# Mulgoa Rise Public School

State Significant Development Assessment  
SSD 11070211

Title: New Primary School at Mulgoa Rise

**Figure 12 |** Flood levels of the proposed development during 1% AEP event (Source: Applicant's RtS)

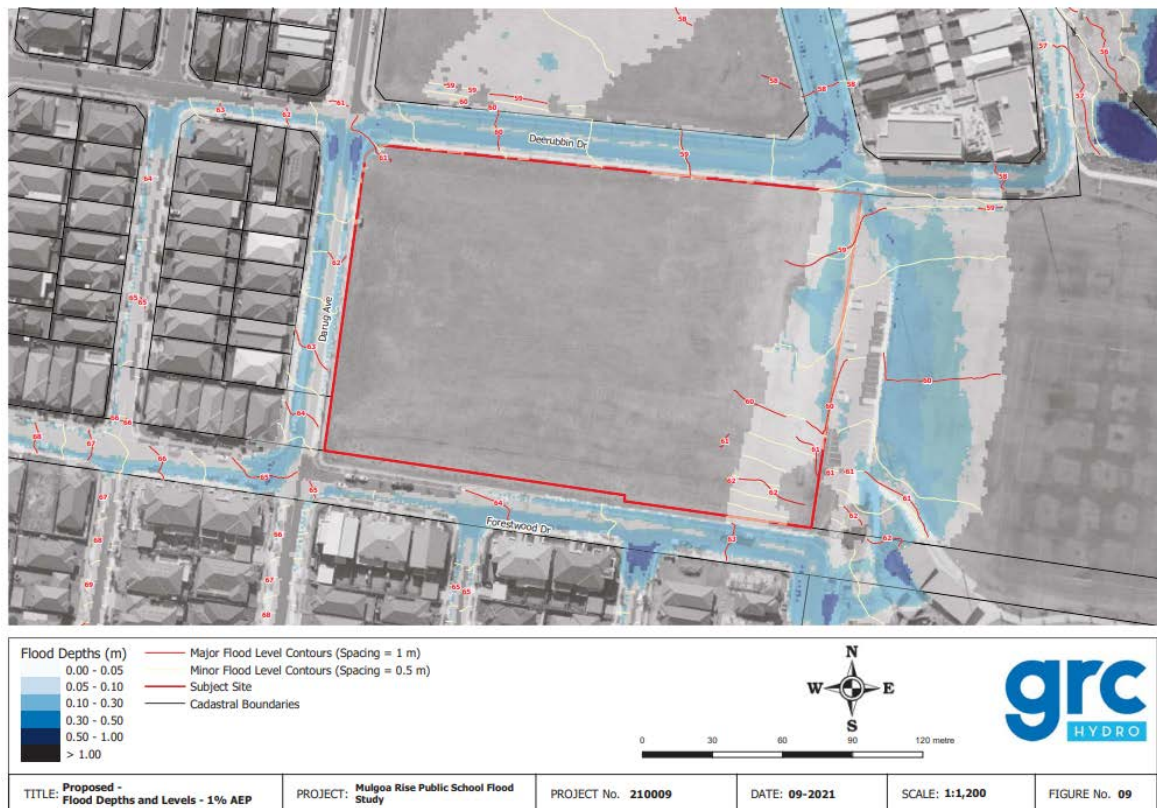
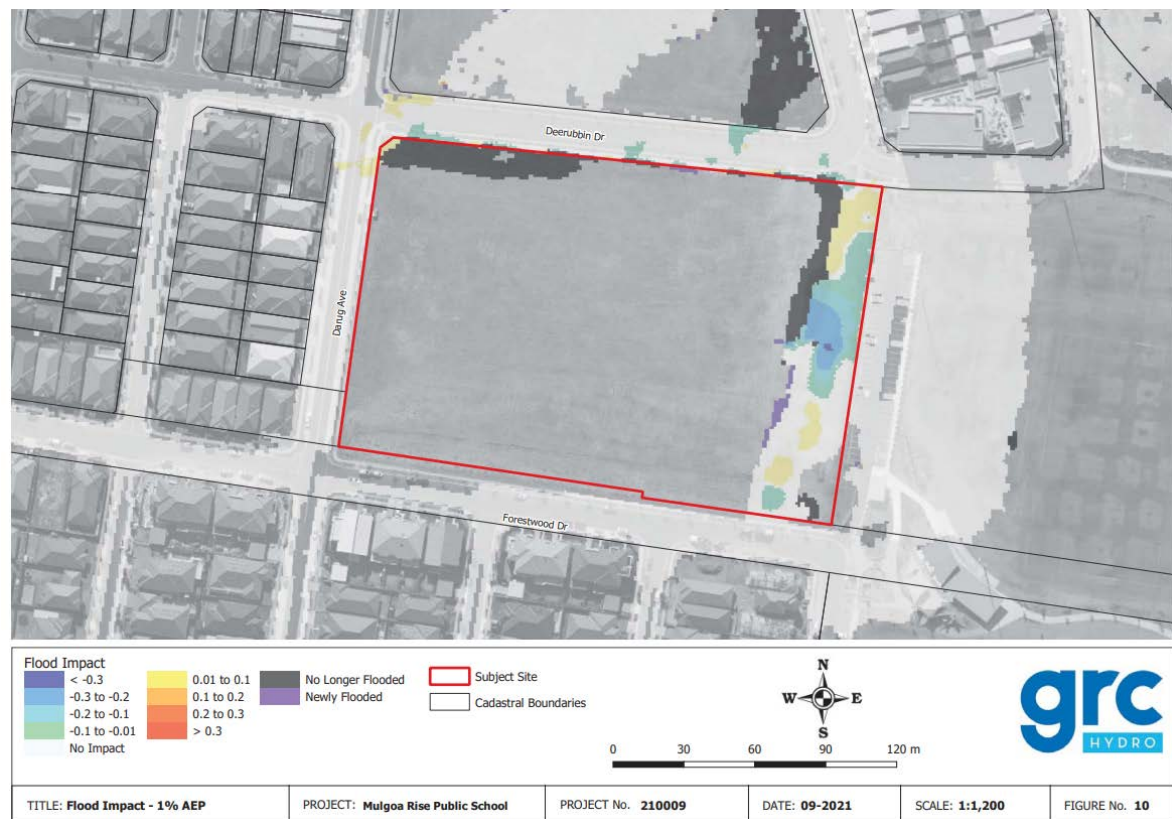
During agency consultation, Council requested that the updated flood modelling include ground survey data to capture gutter depths and LiDAR data. In addition, Council requested that the updated study be submitted to Council for review. EESG requested a review of the flood level contours presented in the Report because a figure displayed flood levels 20m+ above the ground level at the site. EESG also requested that safety measures be implemented to ensure the safety of the school community accessing the school in response to the high flood hazard rating during the PMF on the streets around the school.

The Department sought clarification from the Applicant to confirm that the flood level contours in the figure that was identified by EESG were made in error and the Applicant has acknowledged the error. The Department is satisfied that the levels presented in the Figure were incorrect, as the Figure which contains the error also includes the expected flood depths from TUFLOW grid modelling and the flood contour levels in the north-western portion of the figure are of a similar height when compared with other figures within the Update Flood Impact Assessment (Appendix M of the RtS).

The Department considers that whilst the site is not impacted by significant flood characteristics, the need for an emergency response plan for access to and from the school is necessary due to the nature of the development and the predicted overland flooding within the road corridor. Therefore, a condition has been prepared that requires the Applicant to prepare and implement an Operational Flood Emergency Management Plan (OFEMP) prior to the commencement of operation. The OFEMP would be required to detail the assembly points, evacuation routes and refuge protocols. The OFEMP would provide staff and school parents a safe and suitable way to manage evacuation and assembly during the operation of the project.

**Figure 14 |** Proposed pedestrian crossing (Source: Applicant's RtS)

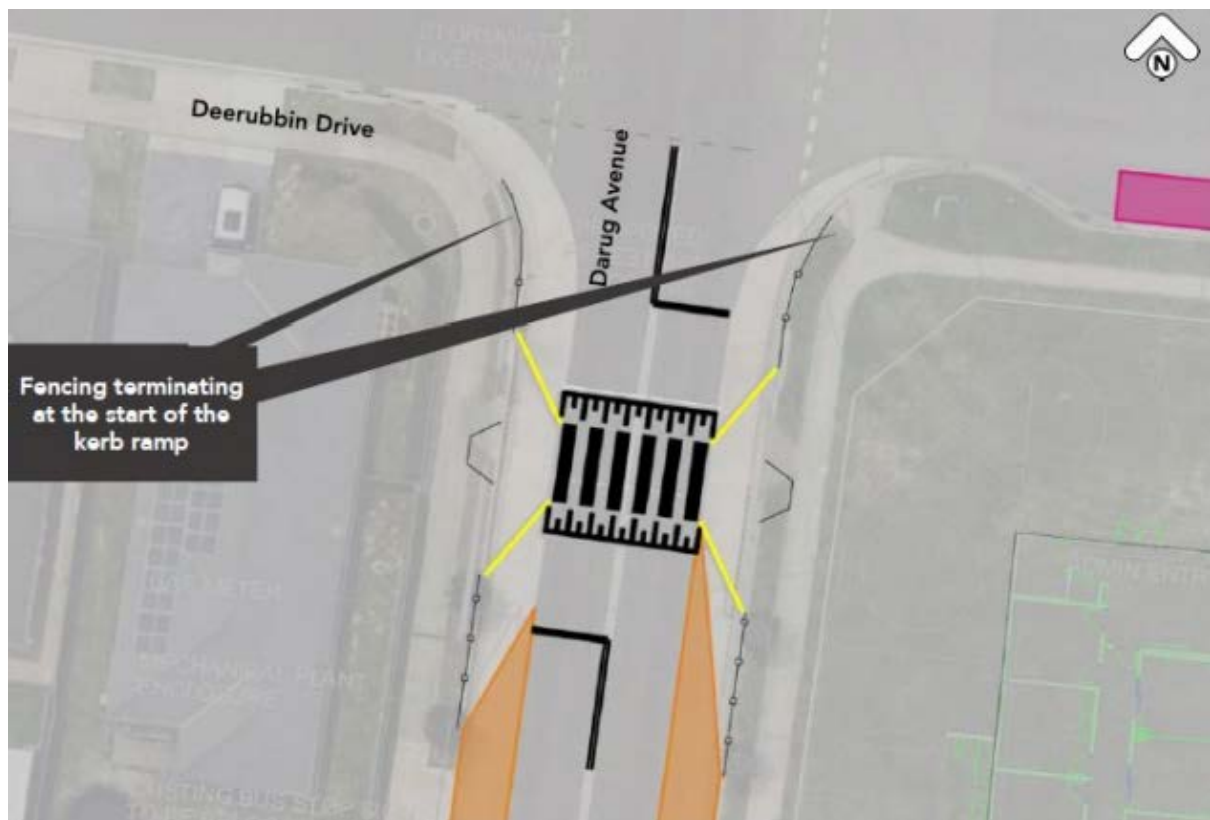
During agency consultation, Council and TfNSW raised concerns with the proposed approach to the delivery of pedestrian infrastructure. Council requested that all crossings be raised children's crossings with no fencing to conform with Council's general design. TfNSW stated that the crossing must be designed in accordance with relevant criteria and that it did not support the use of fencing as part of the zebra crossing as it would reduce the visibility of children approaching the crossing to road users.

TfNSW reiterated that the fencing proposed in yellow in **Figure 14** was not supported. TfNSW also noted that any devices installed in the roadway should be designed to the satisfaction of Council as the local roads' authority.

In response, the Applicant's RtS noted that fencing may reduce the visibility of pedestrians and has proposed using bollards or another form of protection to imitate blister kerbs.

The Applicant proposes to work with Council to develop a solution when the crossing is submitted to Council under the Roads Act. Accordingly, the Department has recommended a condition requiring the Applicant to submit plans and technical specifications to the satisfaction of the road authority for both Darug Avenue and Forestwood Drive crossings. The recommended condition ensures that safe and suitable pedestrian crossings would be provided for the proposal through further design development with Council and through the provision of crossing supervisors.

**Figure 15 and 16** | Flood impact of raised pedestrian crossing (left) and blister kerbs and at-grade crossing (right) (Source: Applicant's Response to RFI)

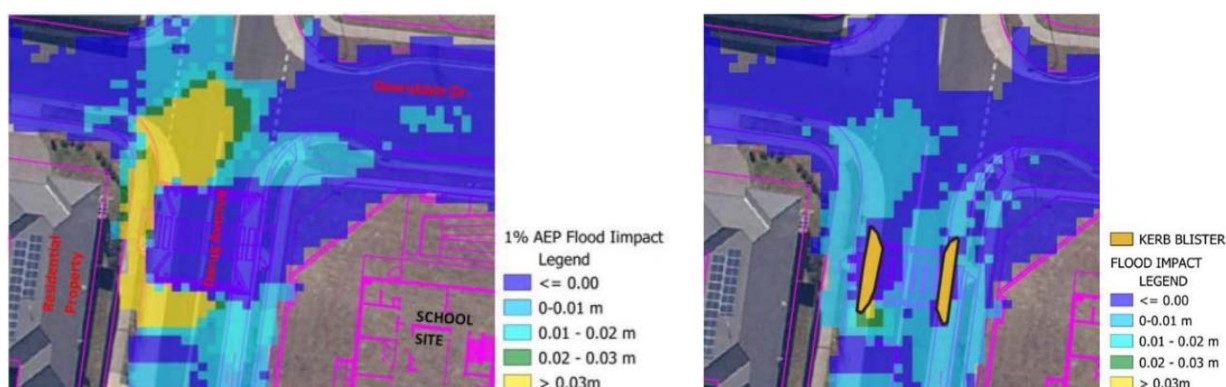
The Applicant's RtS, noted that the provision of a raised crossing or blister kerbs would have a low impact on the site and adjacent properties, but that the inclusion of the infrastructure would worsen the flood hazard to drivers using the intersection of Darug Avenue and Deerubbin Drive. In response, the Applicant proposed that an agreed position with Council can be reached regarding the crossing as part of the approval for all works within the road reserve required by the Roads Act 1993.

The Department has reviewed the Applicant's approach which seeks to develop a solution that provides additional safe crossing facilities for students and ensures the safety of road users (both pedestrians and vehicles) and adjacent private properties. The impacts of any raised crossing on the adjacent property during the 1% AEP event are not acceptable due to the increased risk to property and vehicle movements. The Department is satisfied that the concerns raised by Council regarding risk of pedestrian safety for the crossing at Darug Avenue could be addressed through the design features outlined in **Table 6**. The design features meet the requirements for the scale and usage of the road in the TfNSW guidelines whilst also reducing potential flooding impacts to both people and property. The use of fencing is not supported as an imitation of kerb blisters.

**Figure 17 | Proposed construction vehicle access (Source: Applicant's EIS)**

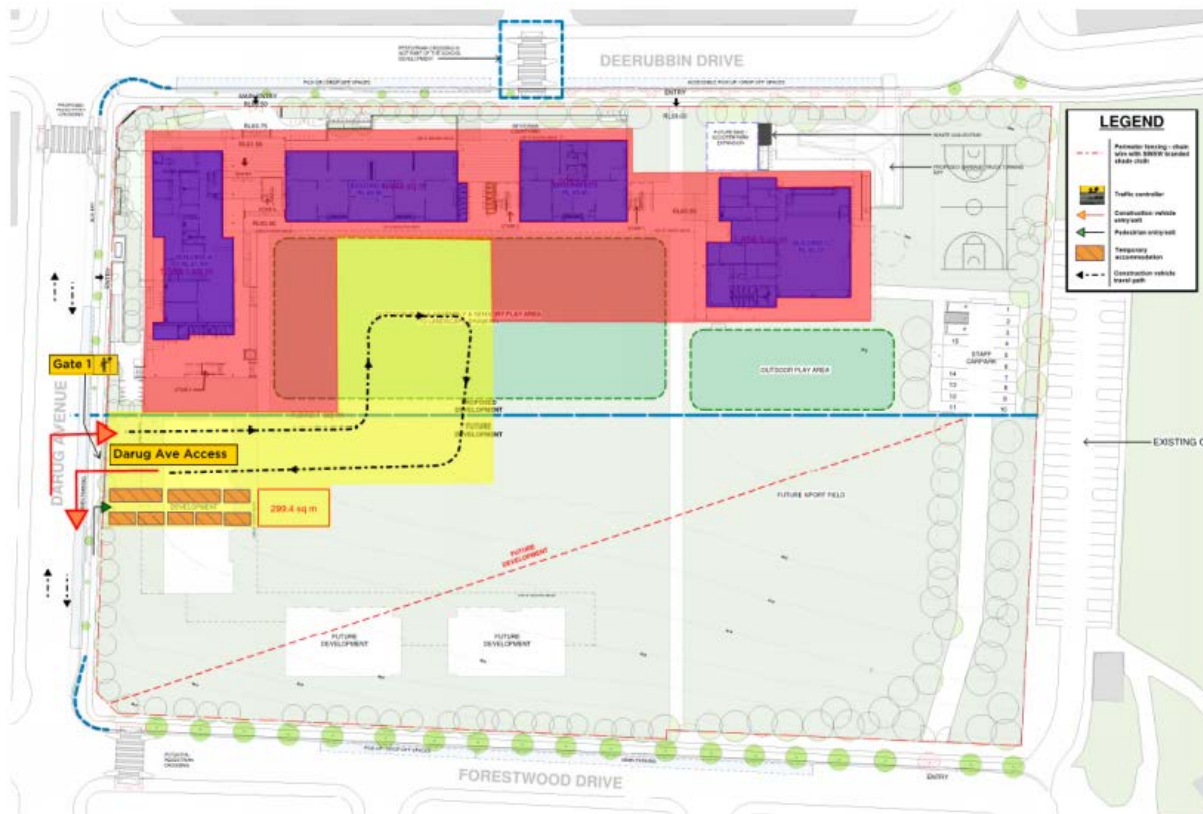
Council and TfNSW provided comments on the PCTPMP. Council requested that a dilapidation report of the proposed construction routes be prepared prior to construction and that any installation of road signage be submitted to the Local Traffic Committee for approval. TfNSW noted:

- the requirement to prepare a dilapidation report was noted
- whilst vehicles accessing the site would be required to give way to southbound traffic, the CTMP would include an additional traffic controller on Darug Avenue
- the swept paths of Bradley Street/Darug Avenue intersection in the PCTPMP displayed the simultaneous movement of two trucks. In response to TfNSW's concerns, the Applicant stated that the two movements at the intersection traffic controllers would be installed at the southbound approach on Darug Avenue and the westbound approach on Bradley Street (as shown in **Figure 18**).

The Department has reviewed the PCTPMP and is satisfied that the proposed management of construction traffic accessing the site is suitable. However, the lack of detail regarding the expected construction traffic volumes or parking either on-site or on local roads requires the preparation of a detailed Construction Traffic Management Plan prior to the commencement of construction. The Department has recommended a condition that requires the preparation of a Construction Worker Parking Survey to manage and minimise the impacts of construction worker parking.

**Figure 20 | Revised Site Access and Security Plan (Source: Applicant's RtS)**

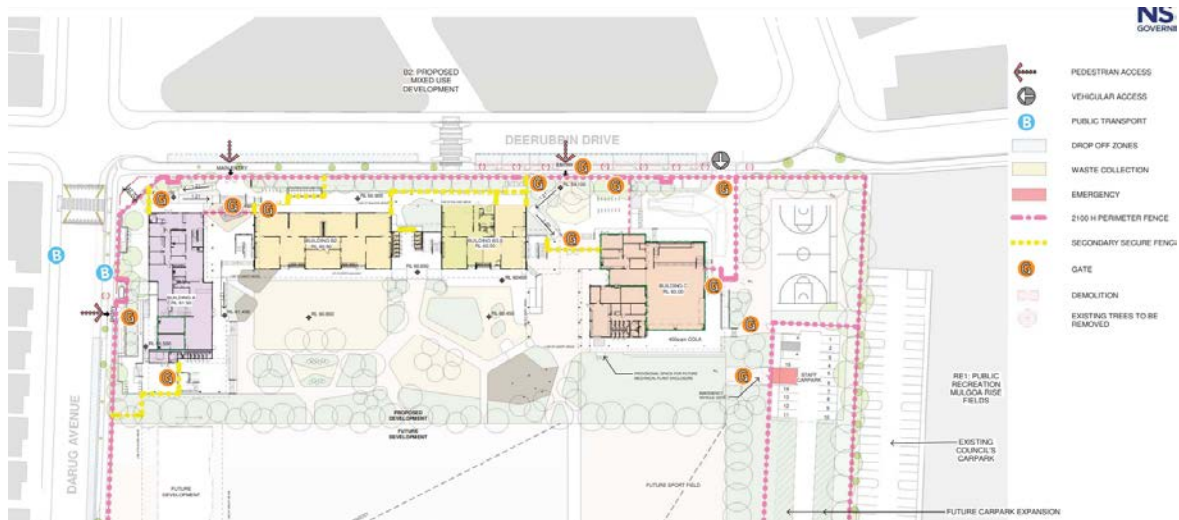
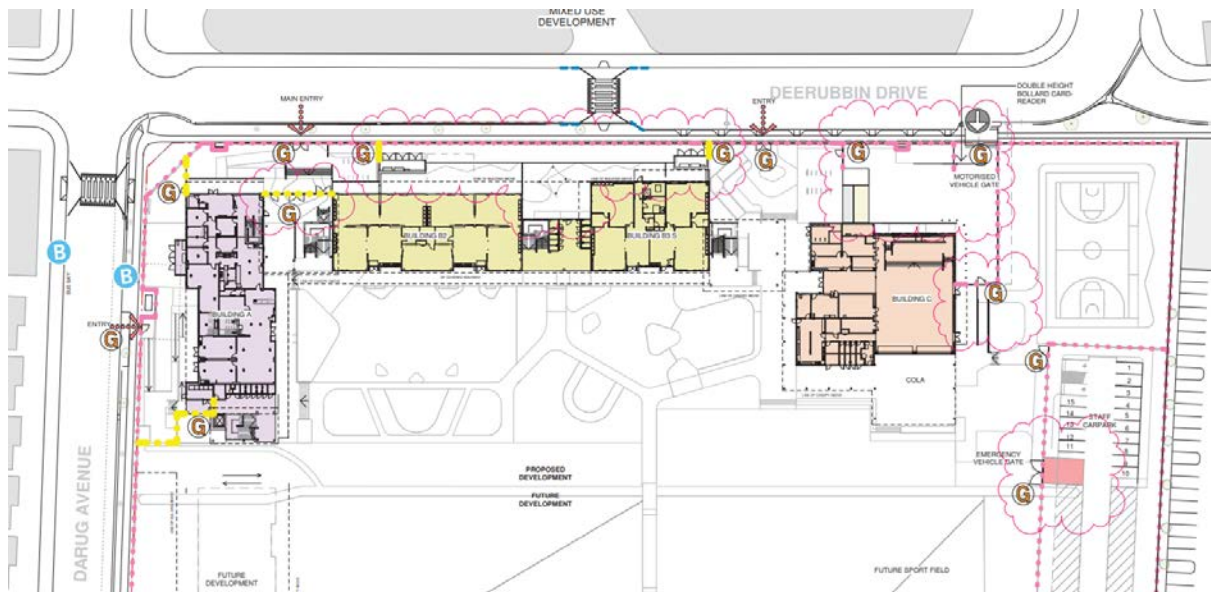
The Architectural Plans submitted as part of the EIS showed that there would be significant secondary fencing provided behind the main perimeter fencing (as shown in yellow in **Figure 19**).

The SDRP raised concerns with the duplication of fencing and requested that the fencing around the site was simplified and that the role and size of spaces between the street and fencing be reviewed, with the aim of having a single line of security around the site.

In the RtS, the Applicant undertook further design refinement and was able to reduce a significant amount of the secondary fencing (as shown in **Figure 20**) and provide improved integration.

The Department is supportive of the revised fencing and the rationalisation of the built form using balustrades to manage safety at the areas of elevation change. The fencing proposed provides a safe and secure school environment and improved integration and visual amenity.

**Figure 22 | Planting in the front setback along Deerubbin Drive (Source Left: Applicant's EIS and Source Right: Applicant's RTS)**

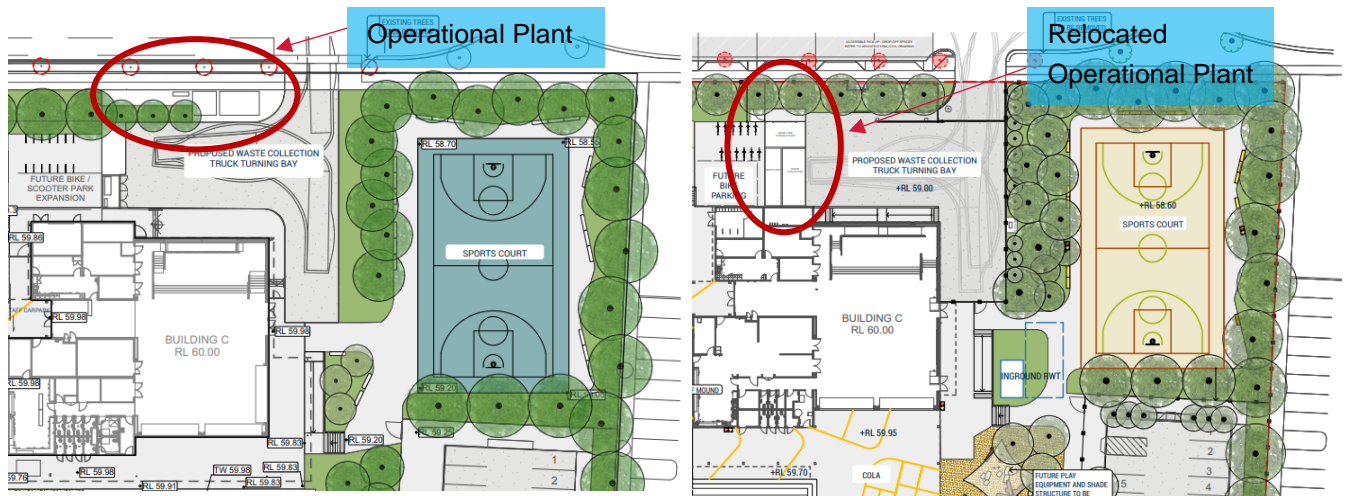
During exhibition, Council raised concerns regarding the interface of the service vehicle entry off Deerubbin Drive and the placement of operational plant (including fire hydrant pumps, plant rooms and water meter) along the fence line as it would reduce the visual and urban amenity of the area. Council requested that planting within the front setback would be critical in providing screening of the hardstand and the operational plant. GANSW also raised the location of the waste collection area as a concern as it would reduce the opportunities for the interface of the school hall with the wider community.

In response to the concerns raised regarding the placement of the waste collection facility, the Applicant revised the location of the operational plant (excluding the water meter as it is required to be located along the property boundary) to allow for additional planting along the front setback. The Applicant also provided an options analysis of the possible locations where a waste collection area could be located. The analysis demonstrated that the proposed location would be best suited due to:

The Department considers the revised design of the front setback, including the relocation and design integration of the operational plant and increased street tree canopy, provides an enhanced street amenity and pedestrian experience. The location of the waste collection area is supported as it is suitably located for both operational requirements (both for staff and for future connections to Council's open space) and pedestrian safety, whilst providing improved public amenity.
